STAFF RECOMMENDATION 1614 Benjamin Street April 17, 2013

Application: New construction – infill and outbuilding
District: Eastwood Neighborhood Conservation Zoning Overlay
Council District: 06
Map and Parcel Number: 08306003300
Applicant: Bill Franklin, Owner
Project Lead: Melissa Baldock, melissa.baldock@nashville.gov

<p>Description of Project: Application is to construct a one-and-a-half story primary structure and a one-story outbuilding.</p> <p>Recommendation Summary: Staff recommends approval of the project with the following conditions:</p> <ol style="list-style-type: none">1. Staff review and approve the asphalt shingle color, a brick sample, the window and door specifications, and the materials for the porch floor and steps.2. The utilities be located on the rear of the house, or on a side façade beyond the midpoint of the house.3. Staff review and approve all appurtenances not included on the site plan. <p>With these conditions, staff finds that the project meets Section II.B.1. of the <i>Eastwood Neighborhood Conservation Zoning Overlay: Handbook and Design Guidelines</i>.</p>	<p>Attachments A: Context Photos B: Site Plan C: Elevations</p>
--	---

1 SITE / ROOF PLAN
 SCALE 3/32" = 1'-0"

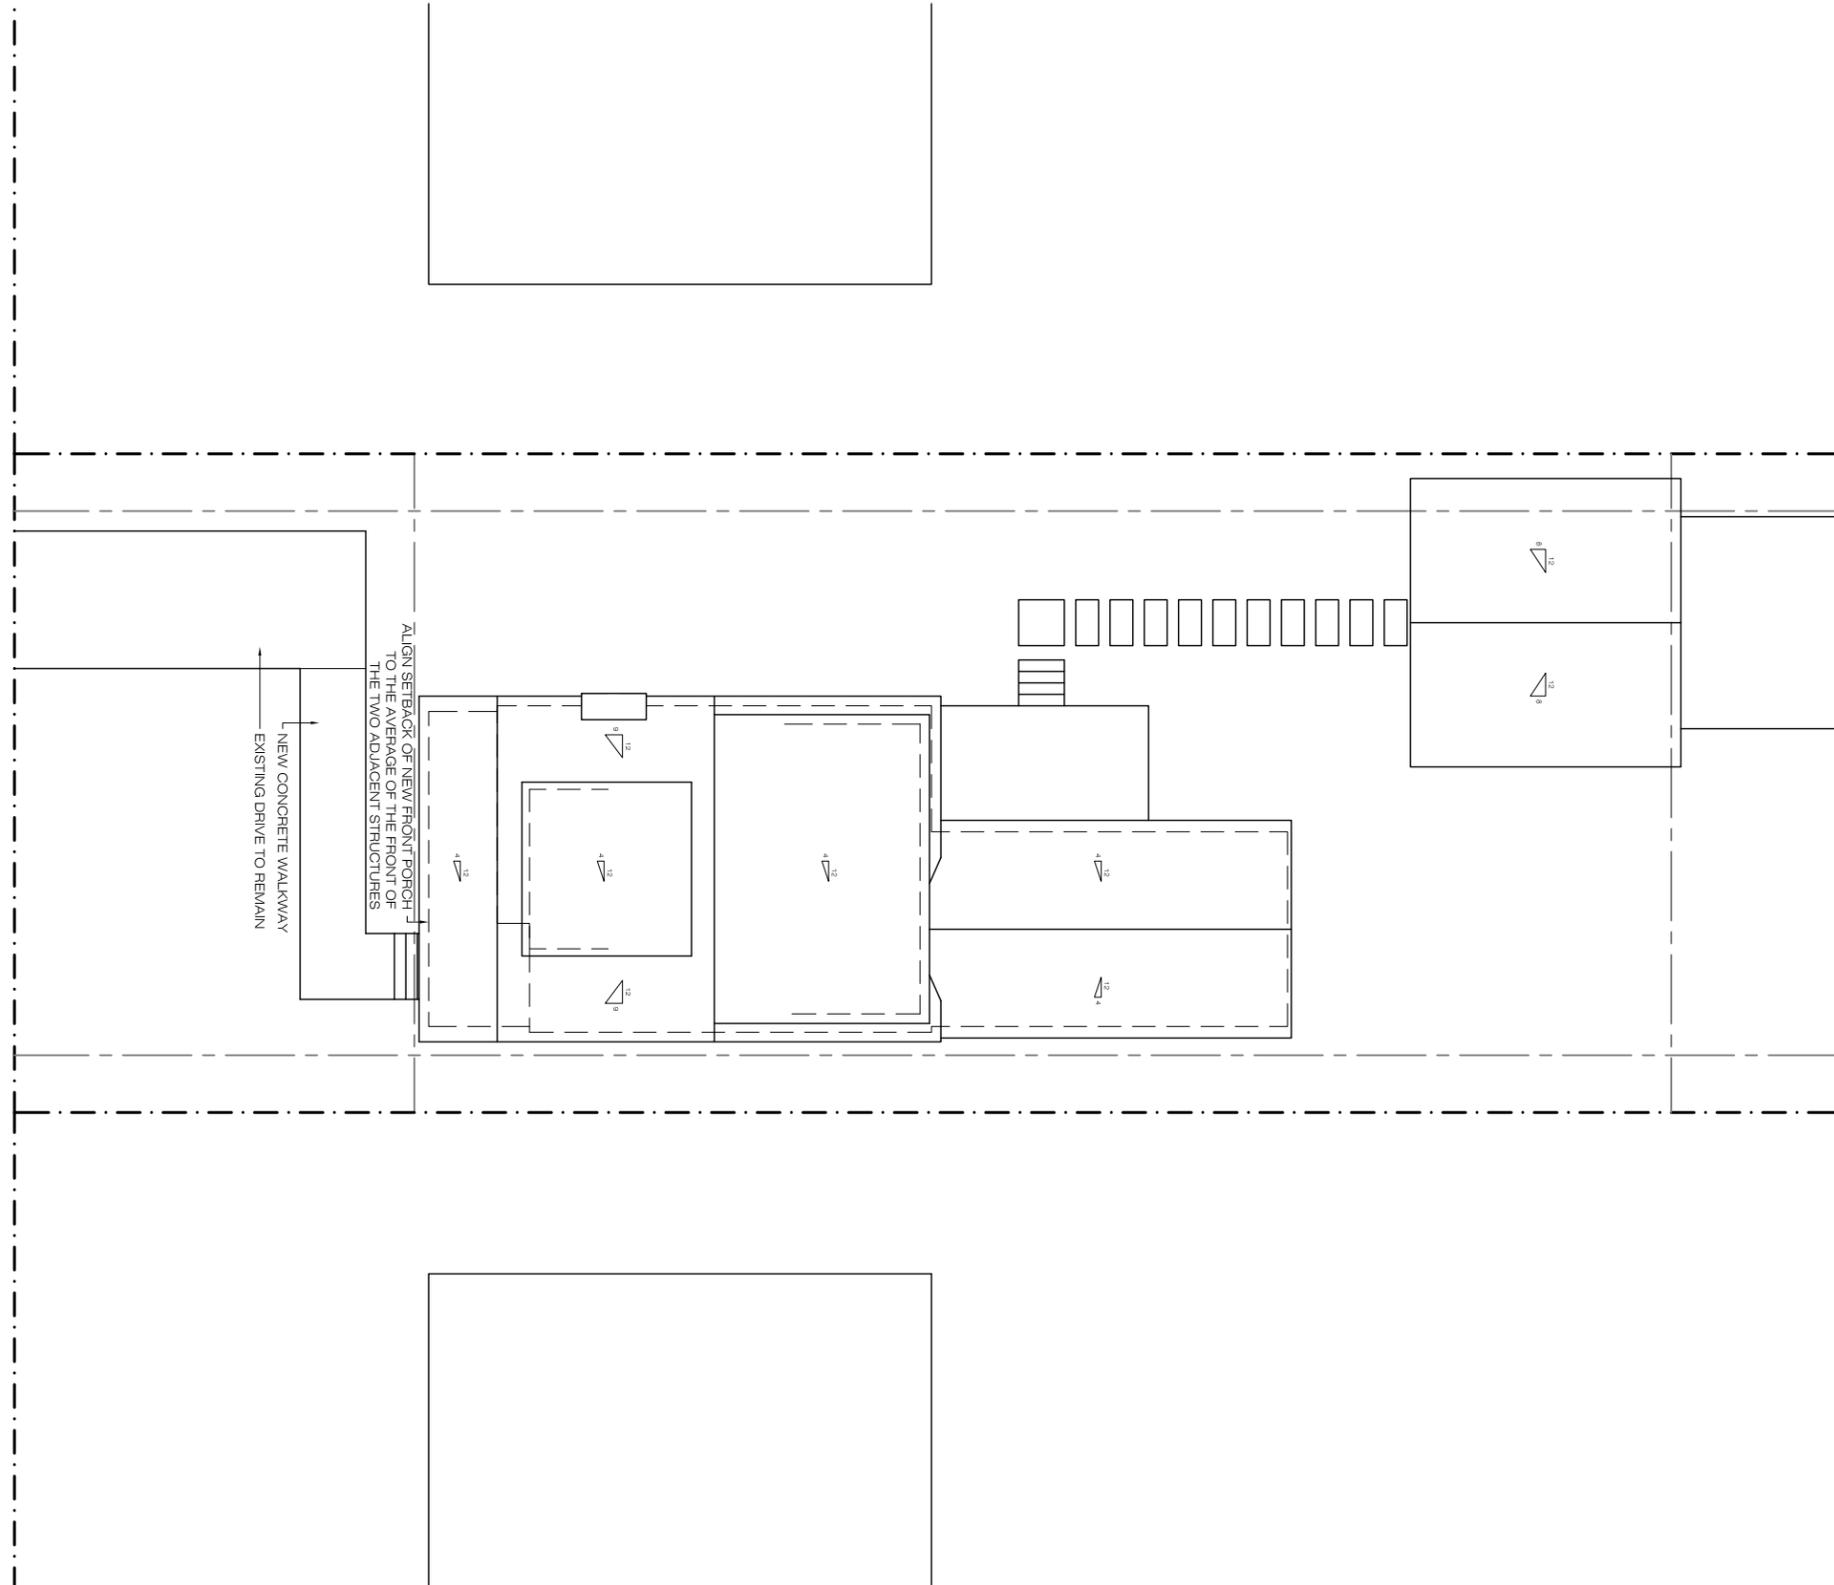
Setback and Rhythm of Spacing: The primary structure meets all base zoning requirements for setbacks. The front setback of the structure will be similar to that of the existing historic house, which will be demolished due to economic hardship. The front setback will be an approximate average of the two front setbacks of the houses to its left and right, which is appropriate. The primary structure will be shifted towards the right on the lot so that it is approximately six feet (6') from the right side property line and twenty feet (20') from the left side property line. Staff finds the proposed shift to be appropriate because the existing house on the site is also shifted to the right of the site, although not as much as the proposed infill, and other houses on the block are shifted to the side to allow for a side driveway off of Benjamin Street. Staff finds the setback and rhythm of spacing for the primary structure to meet Section II.B.1.c. of the *Eastwood Neighborhood Conservation Zoning Overlay: Handbook and Design Guidelines*.

Public Spaces and Appurtenances: The existing front driveway will remain as part of the project (see photo). The applicant is proposing to add a concrete walkway leading from the existing driveway to the primary structure’s front porch. No other appurtenances were indicated on the drawings. Staff review and approve all appurtenances not included on the site plan.

1. Staff review and approve the asphalt shingle color, a brick sample, the window and door specifications, and the materials for the porch floor and steps.
2. The utilities be located on the rear of the house, or on a side façade beyond the midpoint of the house.
3. Staff review and approve all appurtenances not included on the site plan.

1 GARAGE PLAN
SCALE 3/32" = 1'-0"

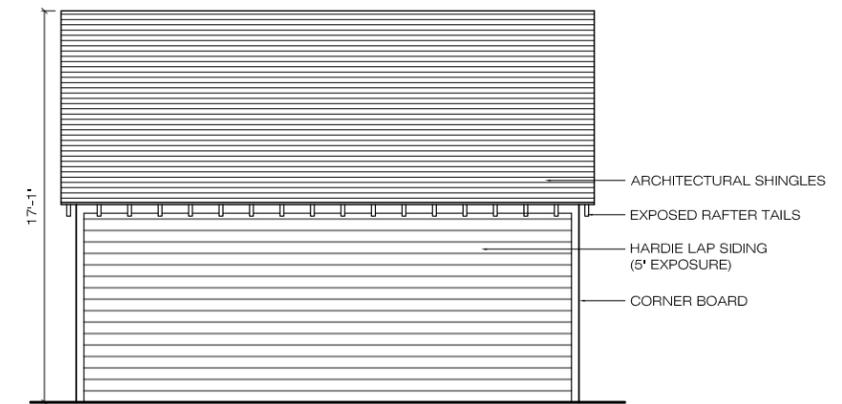
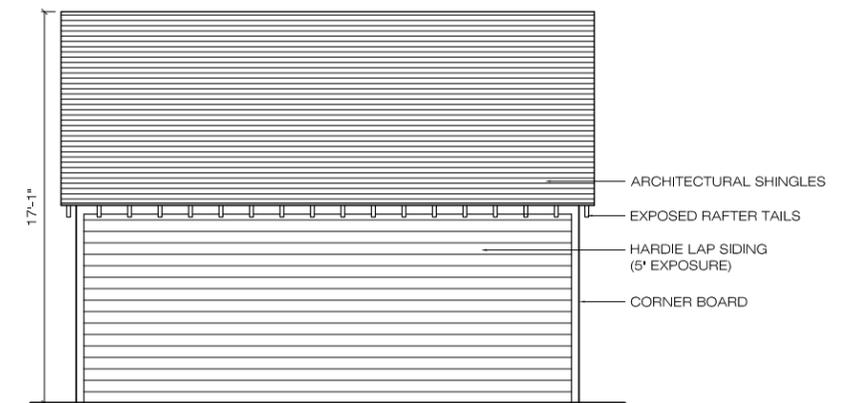
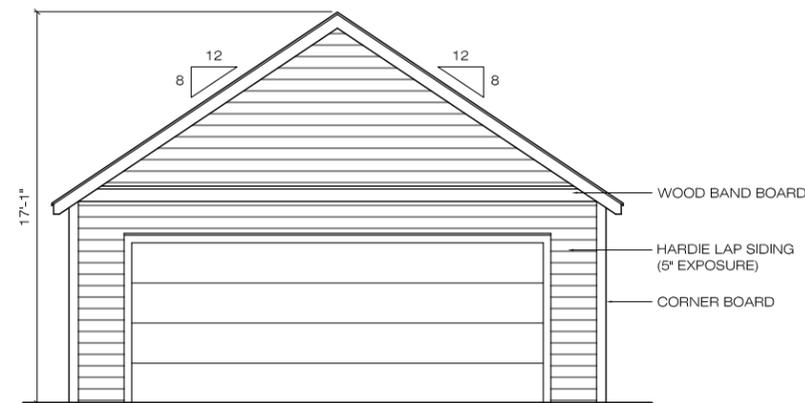
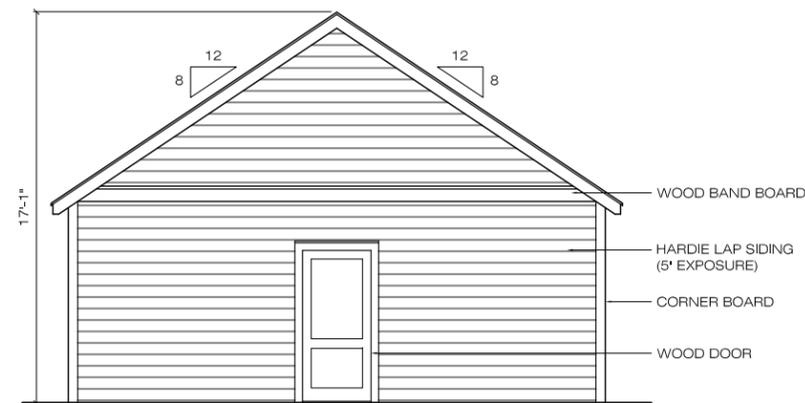
Outbuilding: A one-story accessory structure is proposed for the rear of the property and will be accessed from the alley, which is appropriate. The accessory structure meets all base zoning requirements for setbacks. It is at least three feet (3’) from the side property lines and is ten feet (10’) from the rear property line. The structure will be one-story, with an eave height of approximately nine feet, nine inches (9’9”) and a ridge height of seventeen feet, one inch (17’1”). The accessory structure will be twenty-two feet by twenty-three feet, six inches (22’X23’6”), or five hundred and seventeen square feet (517 sq. ft.). It will have a gabled roof with a slope of 8/12. The materials for the accessory structure include cement fiberboard siding with at five inch (5”) reveal, architectural shingles, wood pedestrian door, wood band board, and concrete slab foundation. The only openings are a vehicular door opening and a pedestrian door. No window openings are included, which is appropriate for an accessory structure. Staff finds that the accessory structure’s location, setback, height, scale, orientation, and proportion and rhythm of openings are subordinate to the primary structure and do not contrast greatly
